Affected Date Code: All orders placed before **10/25/2024** will be pre-PCN parts. Orders placed after **10/25/2024** will be manufactured in accordance with the PCN. Please check updated 2D drawing on or after **10/25/2024**.

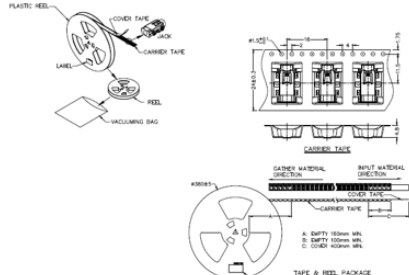
PREVIOUS CUI DETAIL / IMAGE				NEW CUI DEVICES DETAIL / IMAGE																																																					
<table border="1"> <thead> <tr> <th>DESCRIPTION</th> <th>MATERIAL</th> <th>PLATING/COLOR</th> <th colspan="2"></th> </tr> </thead> <tbody> <tr> <td>terminal 1</td> <td>stainless steel</td> <td>silver</td> <td colspan="2"></td> </tr> <tr> <td>terminal 2</td> <td>copper alloy</td> <td>silver</td> <td colspan="2"></td> </tr> <tr> <td>terminal 3</td> <td>copper alloy</td> <td>silver</td> <td colspan="2"></td> </tr> <tr> <td>housing</td> <td>PA8T (UL94V-D)</td> <td>black</td> <td colspan="2"></td> </tr> </tbody> </table>				DESCRIPTION	MATERIAL	PLATING/COLOR			terminal 1	stainless steel	silver			terminal 2	copper alloy	silver			terminal 3	copper alloy	silver			housing	PA8T (UL94V-D)	black			<table border="1"> <thead> <tr> <th>DESCRIPTION</th> <th>MATERIAL</th> <th>PLATING/COLOR</th> <th colspan="2"></th> </tr> </thead> <tbody> <tr> <td>terminal 1</td> <td>stainless steel</td> <td>silver over nickel</td> <td colspan="2"></td> </tr> <tr> <td>terminal 2</td> <td>copper alloy</td> <td>silver over nickel</td> <td colspan="2"></td> </tr> <tr> <td>terminal 3</td> <td>copper alloy</td> <td>silver over nickel</td> <td colspan="2"></td> </tr> <tr> <td>housing</td> <td>PA10T (UL94V-D)</td> <td>black</td> <td colspan="2"></td> </tr> </tbody> </table>				DESCRIPTION	MATERIAL	PLATING/COLOR			terminal 1	stainless steel	silver over nickel			terminal 2	copper alloy	silver over nickel			terminal 3	copper alloy	silver over nickel			housing	PA10T (UL94V-D)	black

DESCRIPTION	MATERIAL	PLATING/COLOR																																																							
terminal 1	stainless steel	silver																																																							
terminal 2	copper alloy	silver																																																							
terminal 3	copper alloy	silver																																																							
housing	PA8T (UL94V-D)	black																																																							
DESCRIPTION	MATERIAL	PLATING/COLOR																																																							
terminal 1	stainless steel	silver over nickel																																																							
terminal 2	copper alloy	silver over nickel																																																							
terminal 3	copper alloy	silver over nickel																																																							
housing	PA10T (UL94V-D)	black																																																							
<p>SOLDERABILITY</p> <table border="1"> <thead> <tr> <th>parameter</th> <th>conditions/description</th> <th>min</th> <th>typ</th> <th>max</th> <th>units</th> </tr> </thead> <tbody> <tr> <td>refl storage¹</td> <td>10-30°C, <10% humidity</td> <td></td> <td></td> <td>40</td> <td>°C</td> </tr> <tr> <td>reflow soldering²</td> <td>see reflow profile</td> <td>255</td> <td>260</td> <td></td> <td>°C</td> </tr> <tr> <td>drying conditions³</td> <td>parts in reel: bake at 110°C for 4 hours parts removed from reel: bake at 110°C for 4 hours</td> <td></td> <td></td> <td></td> <td></td> </tr> </tbody> </table> <p>Notes: 1. CUI Devices recommends to solder within 72 hours from opening vacuum packaging at a temperature <30°C & relative humidity <65%. 2. It is recommended to reflow solder within 72 hours from opening vacuum packaging at a temperature <30°C & relative humidity <65%. 3. When exceeding floor life by >72 hours.</p> 				parameter	conditions/description	min	typ	max	units	refl storage ¹	10-30°C, <10% humidity			40	°C	reflow soldering ²	see reflow profile	255	260		°C	drying conditions ³	parts in reel: bake at 110°C for 4 hours parts removed from reel: bake at 110°C for 4 hours					<p>SOLDERABILITY</p> <table border="1"> <thead> <tr> <th>parameter</th> <th>conditions/description</th> <th>min</th> <th>typ</th> <th>max</th> <th>units</th> </tr> </thead> <tbody> <tr> <td>refl storage¹</td> <td>at relative humidity <60%</td> <td></td> <td></td> <td>40</td> <td>°C</td> </tr> <tr> <td>reflow soldering²</td> <td>see reflow profile</td> <td>255</td> <td>260</td> <td>265</td> <td>°C</td> </tr> <tr> <td>drying conditions³</td> <td>parts in reel: bake at 40°C ±5°C for 72 hours parts removed from reel: bake at 40°C ±5°C for 10 hours</td> <td></td> <td></td> <td></td> <td></td> </tr> </tbody> </table> <p>Notes: 1. It is recommended to reflow solder within 72 hours from opening vacuum packaging at a temperature <30°C & relative humidity <65%. 2. When exceeding floor life by >72 hours.</p> 				parameter	conditions/description	min	typ	max	units	refl storage ¹	at relative humidity <60%			40	°C	reflow soldering ²	see reflow profile	255	260	265	°C	drying conditions ³	parts in reel: bake at 40°C ±5°C for 72 hours parts removed from reel: bake at 40°C ±5°C for 10 hours

parameter	conditions/description	min	typ	max	units																																																				
refl storage ¹	10-30°C, <10% humidity			40	°C																																																				
reflow soldering ²	see reflow profile	255	260		°C																																																				
drying conditions ³	parts in reel: bake at 110°C for 4 hours parts removed from reel: bake at 110°C for 4 hours																																																								
parameter	conditions/description	min	typ	max	units																																																				
refl storage ¹	at relative humidity <60%			40	°C																																																				
reflow soldering ²	see reflow profile	255	260	265	°C																																																				
drying conditions ³	parts in reel: bake at 40°C ±5°C for 72 hours parts removed from reel: bake at 40°C ±5°C for 10 hours
